REMARKS

BELT MOUNTED TOOL HOLDER Michael Musarella et al.

Attorney Docket No.: 87185-3300 Customer No.: 28765

FIG. 15

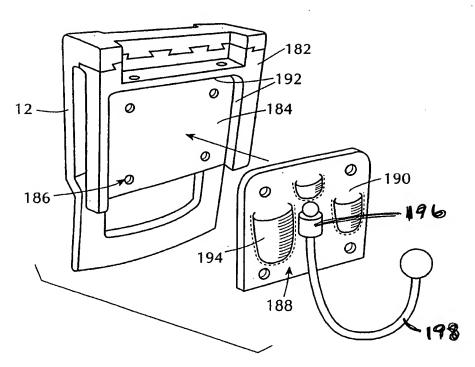
Figure 15 has been amended to include numerals 196 and 198, which are mentioned in the specification in paragraph [0076]. Based on the remaining disclosure of similar features in the rest of the specification, one of ordinary skill in the art would understand what features are referred to by each of these numerals. A formal drawing sheet with this figure is submitted herewith to replace the previous sheet in the file of the application.
